Subject: NYM/2020/0884/FL Application for installation of ground mounted solar array at Hern Head House

Objection to Solar Application James Raynar

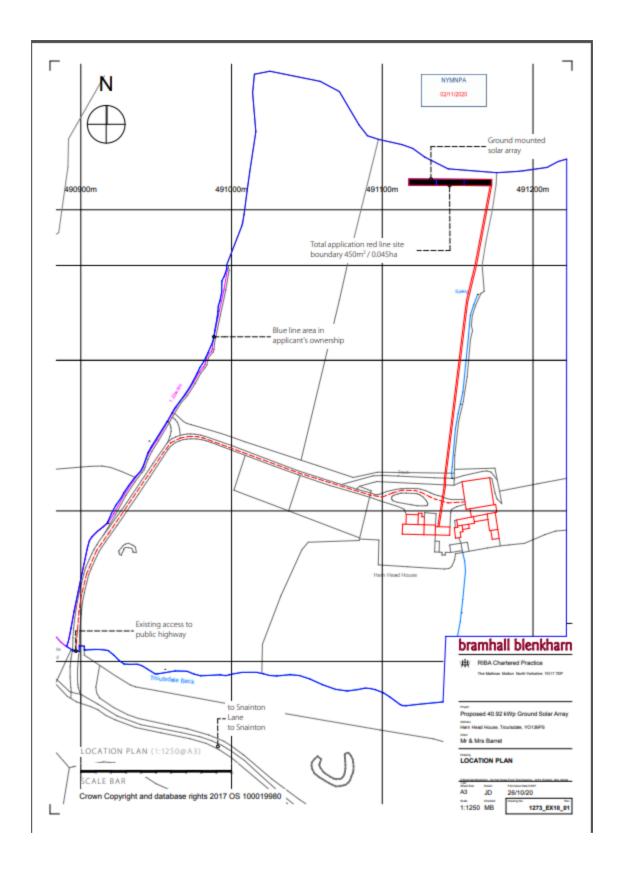
We write further to the attached consultation letter concerning the planning application NYM/2020/0884/FL to raise our concern at the proposed development. This is particularly in respect of the close proximity of the proposed solar array being located so close to the boundary of the adjacent Forestry England Plantation, which is only 5m due north of the application site (see attached Forestry England plan showing the Forestry Boundary at this location). The trees in the plantation (largely conifers planted in 1972) may be expected to reach 40 meters in height and currently the degree of risk to an adjacent landowner's agricultural/pasture land (such as is the land in the subject application) is moderate in respect of the proximity of these types of trees. Siting an electrical generation plant here however, so close to the forest, may be considered an unacceptable and unnecessary risk which could be avoided by the applicant resiting the solar panels some 40m further from the boundary within the same field.

We ask that the application be modified or refused on the grounds of identified risk. The site in question is also shown on the applicant's location plan below.
